**Title:** 24-401: Burl Oaks Golf Course Redesign

**Prepared by:** Name: Maggie Menden  
mmenden@minnehahacreek.org

**Recommendation:**

Approval of the Minnehaha Creek Watershed District (MCWD) permit on the following conditions:

# REQUIRED WETLAND BUFFERS

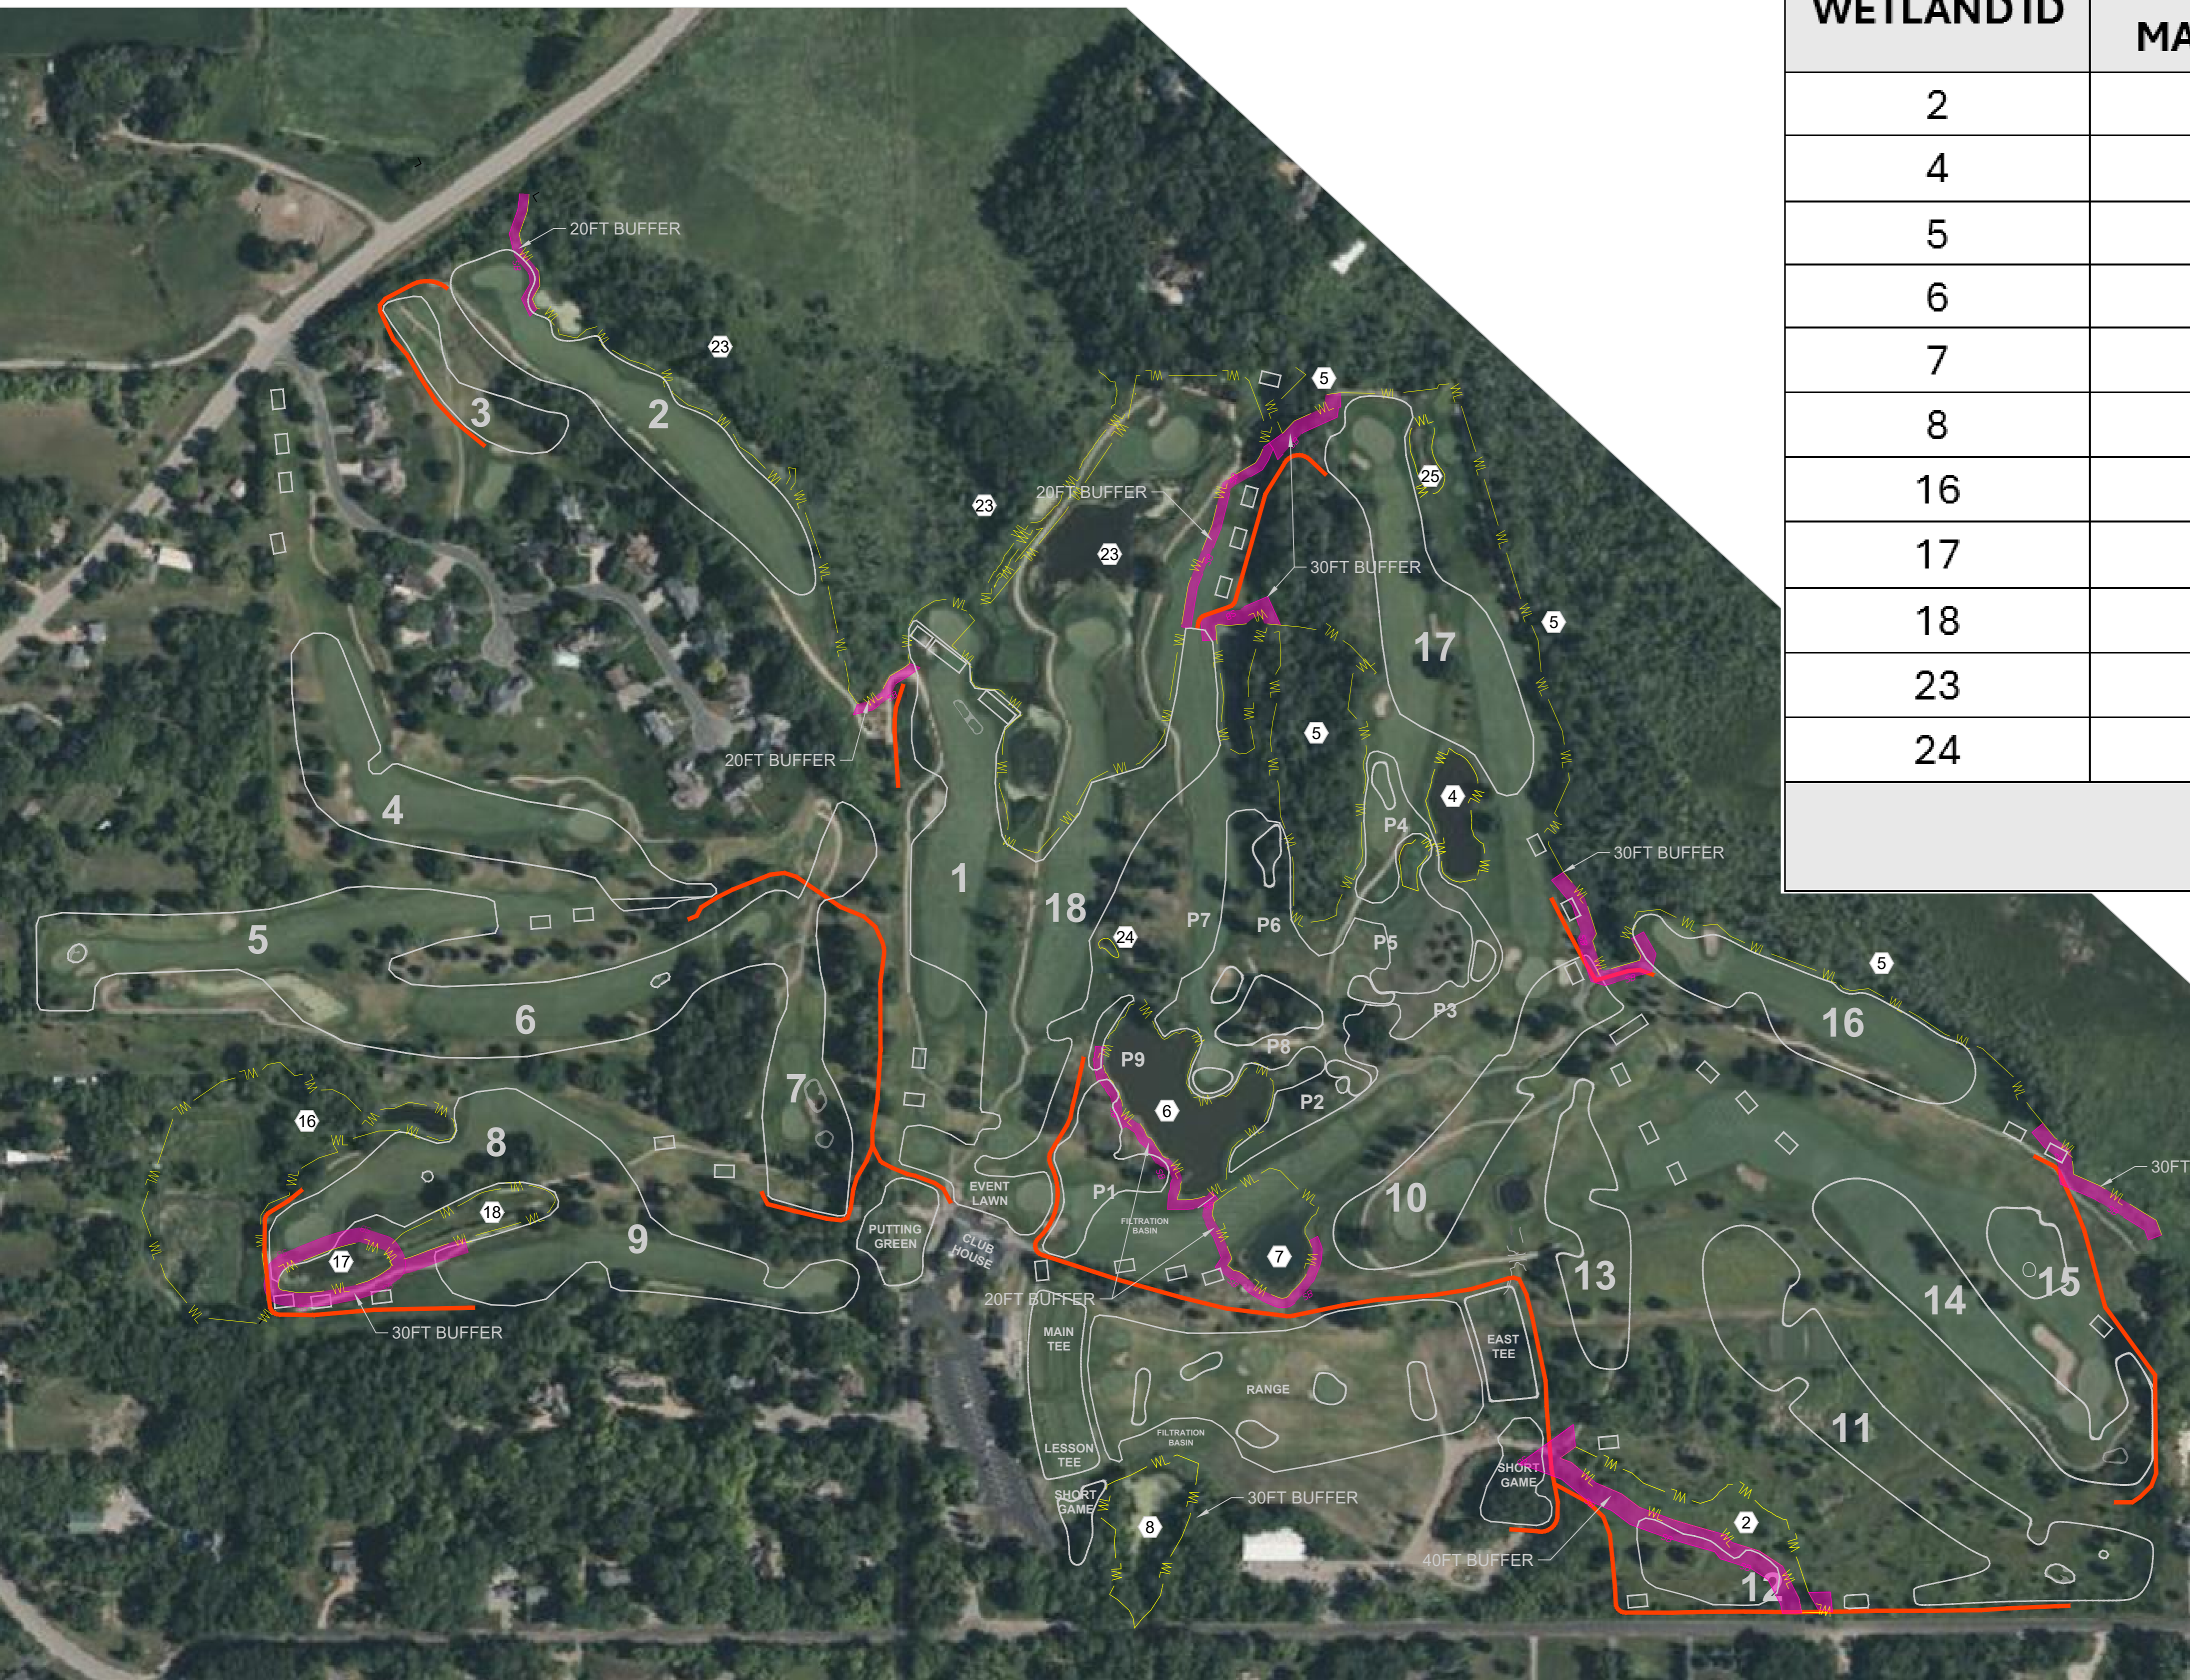
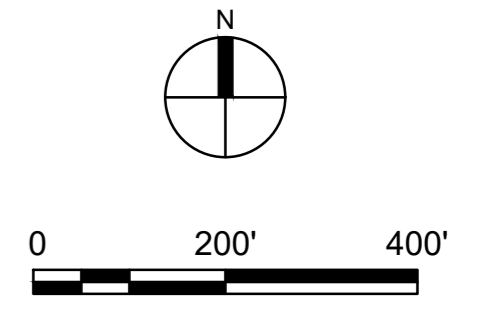
Per section 4(a)(1-2) of the Wetland Protection Rule, a wetland buffer is required on a wetland disturbed by placement of a new storm sewer structure, or one that is downstream of new or reconstructed impervious surface (cart path). Buffer width is based on the management classification of the wetland, established by the District's Functional Assessment of Wetlands (FAW). This Project consists of Manage 1, 2, and 3 wetlands which require 40, 30, and 20 foot buffers, respectively. The project is required to provide 2.87 acres of wetland buffer, which includes buffers around the entirety of wetland 17, and downgradient of the new cart paths for wetlands 2, 5, 6, 7, 18, and 23, as shown in Attachment D and by the table below.

# PROPOSED FESCUE AREAS AND ADDITIONAL BUFFERS

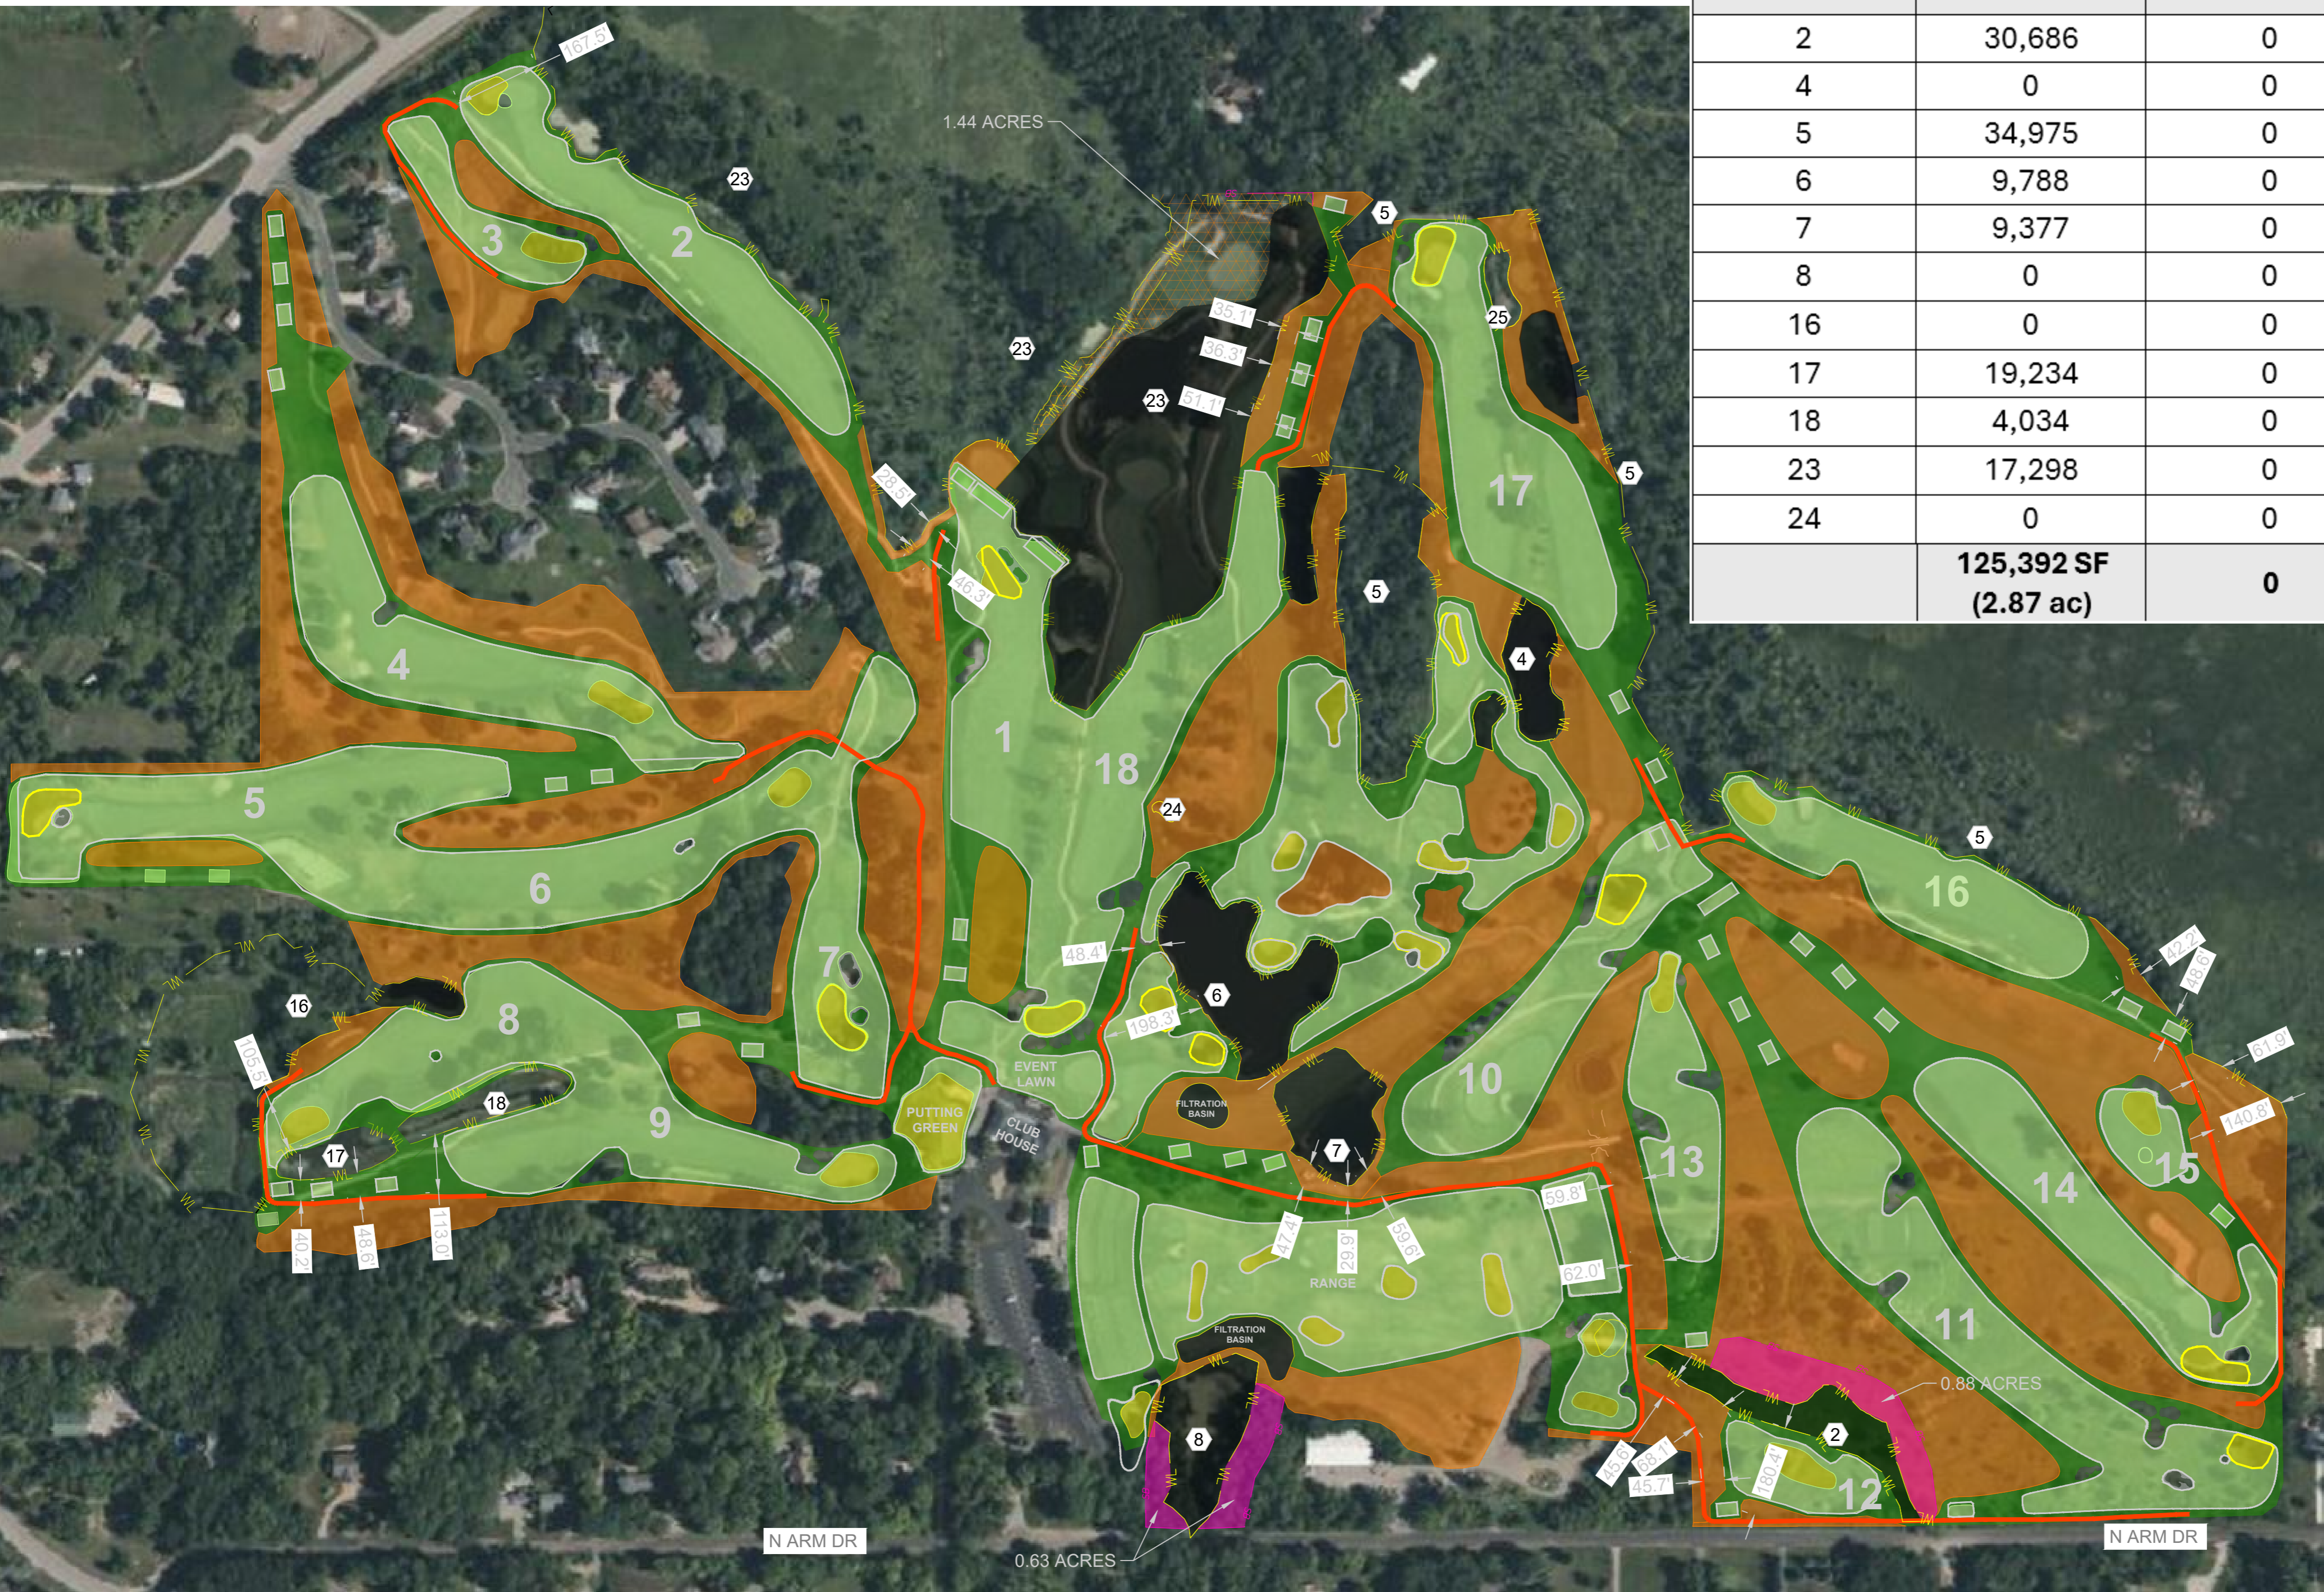
Wetland 2, shown in the table below, is proposed to receive 38,431 square feet of buffer, but not immediately downgradient of the cart path. Wetland 8 is not required to have buffers but is proposed to have 27, 512 square feet of buffer. Together, these wetlands will provide 1.51 acres of natively planted buffer. While not eligible as wetland buffer, the applicant is also proposing 2.26 acres of low maintenance fescue grass around wetlands 2, 5, 7 and 23.

While the applicant is not proposing buffers in required locations downstream of cart paths, 1.51 acres of natively planted buffers are being proposed around Wetland 2 and 8. These buffers represent 52% of the total required buffer acreage and will provide additional water quality filtering and habitat functions in these locations.
